**Final Supplement to the**

**Final Environmental Impact Report**

**Prepared for Pumice Valley Landfill**

**June, 2005**

**FIGURE 1**  
**SAGE GROUSE USE AREAS, MONO BASIN**

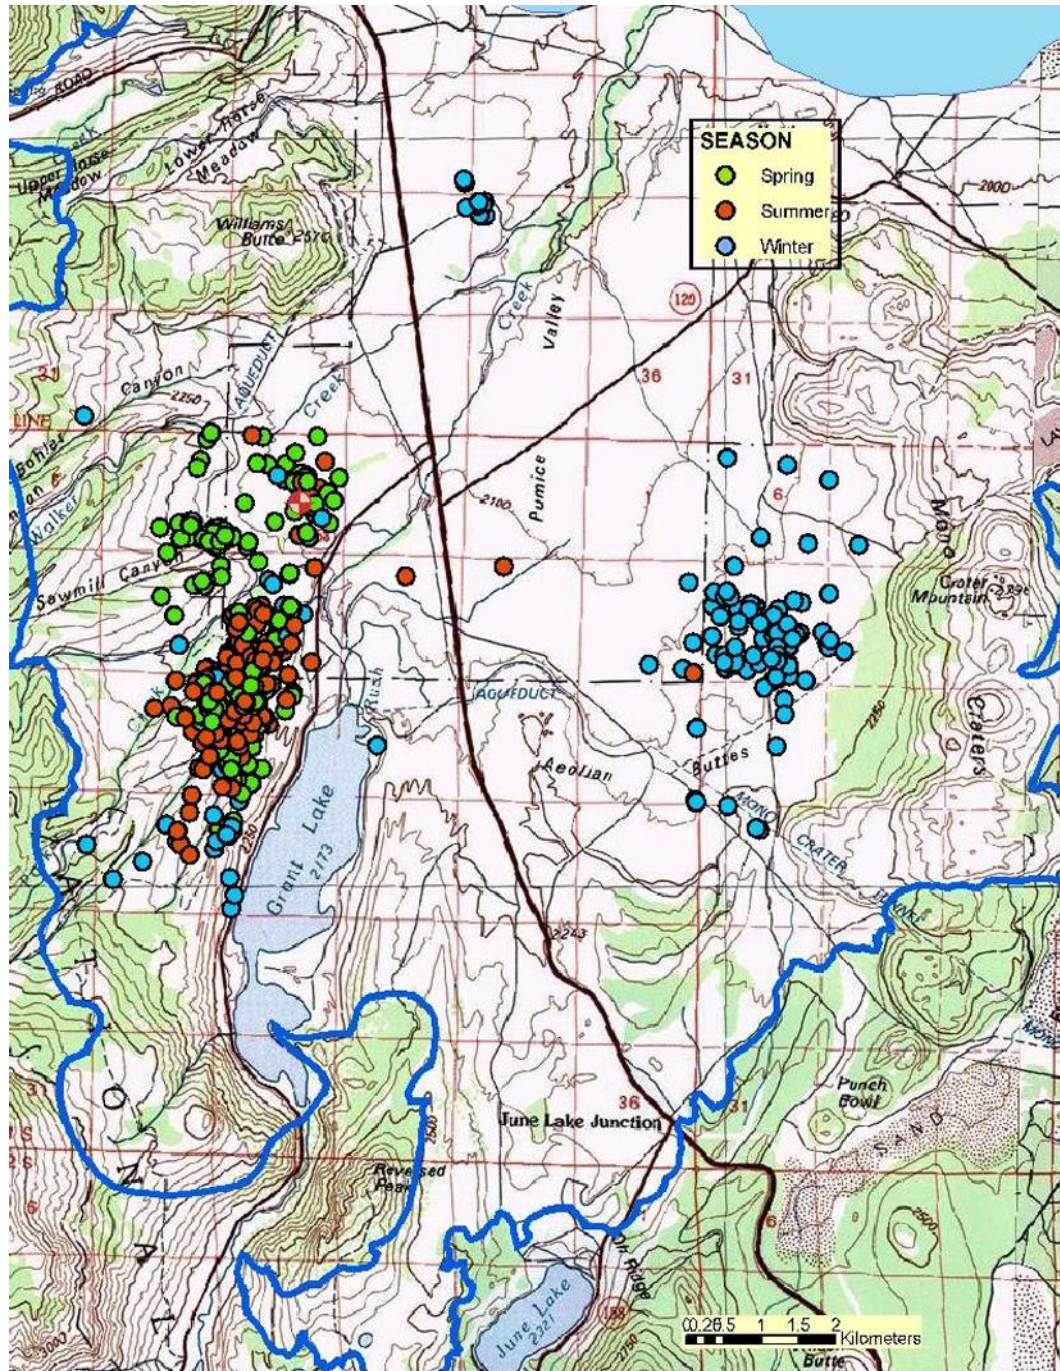
**Comment 1-A:** Provides additional information concerning sage grouse use in the area and discusses sage grouse impacts and mitigation. Specific concerns include:

**Response 1-A:** Mono County is aware of the current sage grouse conservation efforts occurring in various areas of the County and utilized data from the **Greater Sage grouse Conservation Plan for the Bi-State Plan Area of Nevada and Eastern California** (June 2004) in developing the analysis in the DEIR. At the time the DEIR was completed, there were no maps of telemetry findings available for the Mono Basin unit. The attached map of sage grouse use in the Mono Basin (see Figure 1) is incorporated herein as part of the EIR for the Pumice Valley Landfill.

The following paragraph in the DEIR has been revised to acknowledge habitat characteristics on-site appropriate for seasonal use and to acknowledge findings from the telemetry studies of sage grouse in the Mono Basin (deletions are indicated in ~~strike-through print~~, additions are in ***bold and italic print***):

Impacts to sage grouse from the proposed operation of Pumice Valley Landfill through 2023 will be less than significant ~~since the area surrounding the landfill is not a major sage grouse use area, the surrounding habitat does not provide suitable habitat for sage grouse throughout the year, and scavengers are not attracted to the landfill since only inert debris and construction and demolition waste are buried there.~~ ***As shown on the map of sage grouse use in the Mono Basin, sage grouse use in the area is concentrated in two distinct areas. In the spring and summer, they use the riparian areas and meadows west of Highway 395; in the winter, they use sagebrush habitat at higher elevations in the Mono Basin, predominantly at the base of the Mono Craters. There is only limited use of the area adjacent to Mono Lake, east of Highway 395 and north of Highway 120, where the landfill is located. The landfill itself, and the area surrounding the landfill, is predominantly tall sagebrush that provides suitable habitat for winter forage. BLM personnel have noted that:***
